Moreno Duplex  
N 14th st.  
Erwin, NC

Job Number:  
1348-22

**Joe Moreno**  
**Mingo A (Left Side of Duplex ONLY)**  
**1st FLOOR I-JOIST PLACEMENT PLAN**

**ROOF PLAN**  
SCALE: 1/4" = 1'-0"

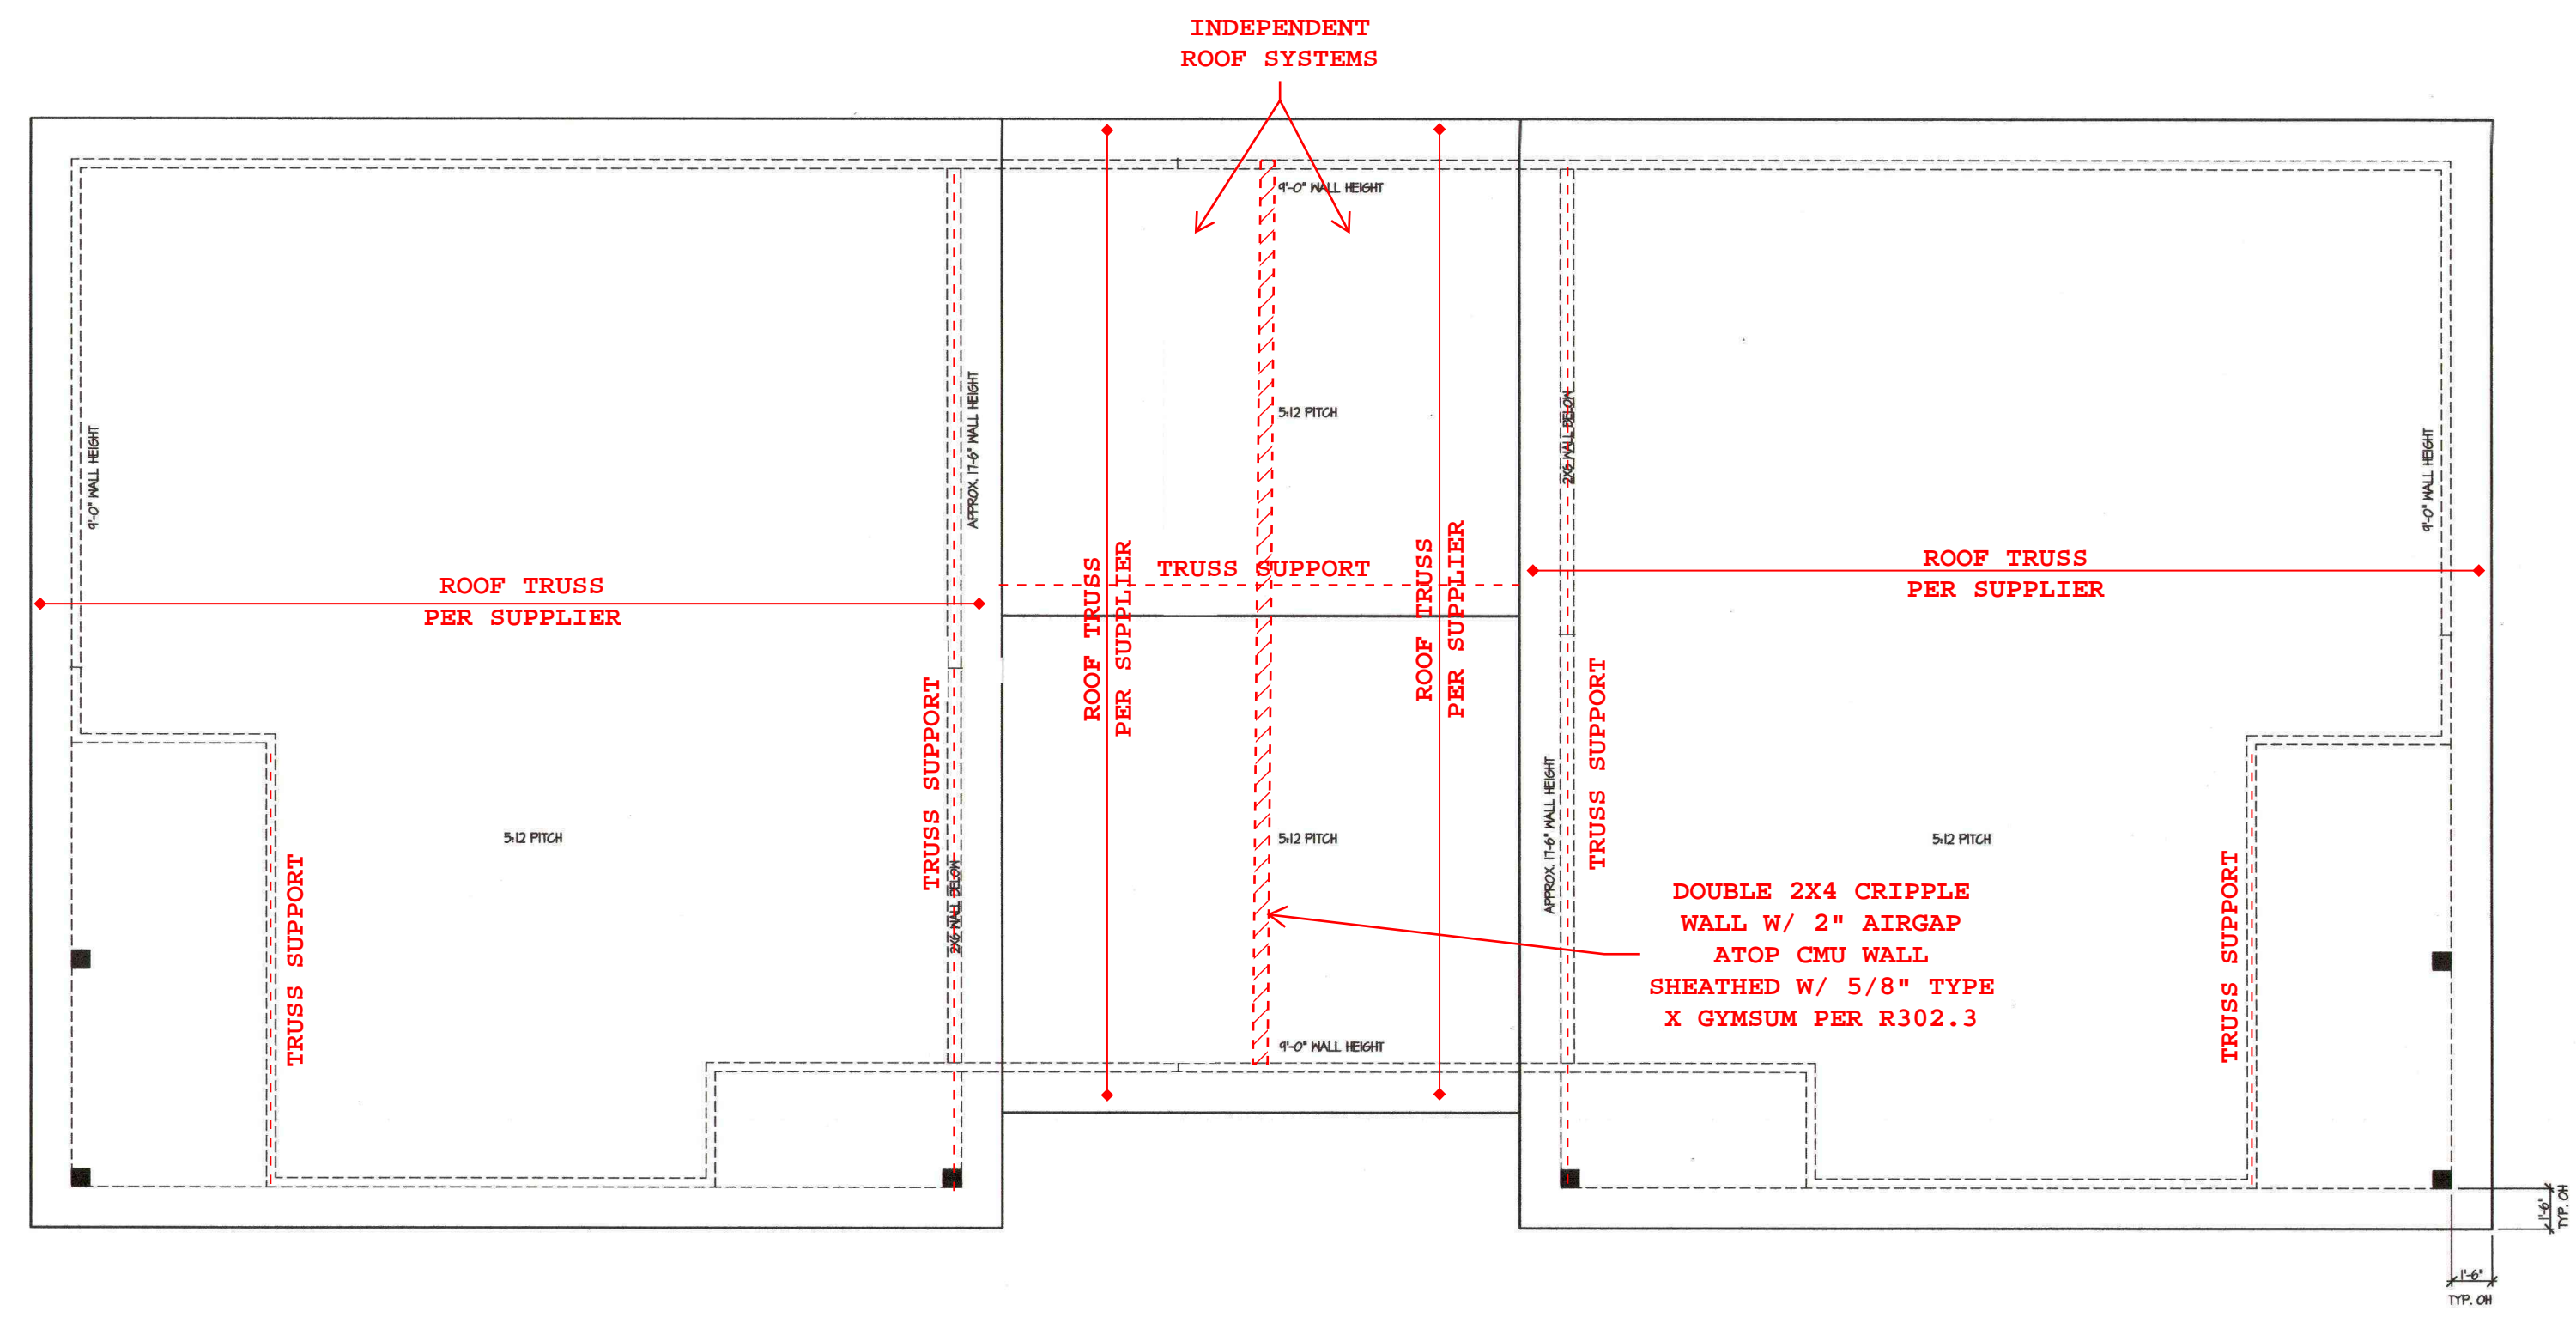
INTERIOR FOOTINGS MAY BE NEEDED DEPENDING ON TRUSS DRAWINGS TO BE PROVIDED BY TRUSS MANUFACTURE. BUILDER IS RESPONSIBLE FOR COORDINATING PRIOR TO CONSTRUCTION.
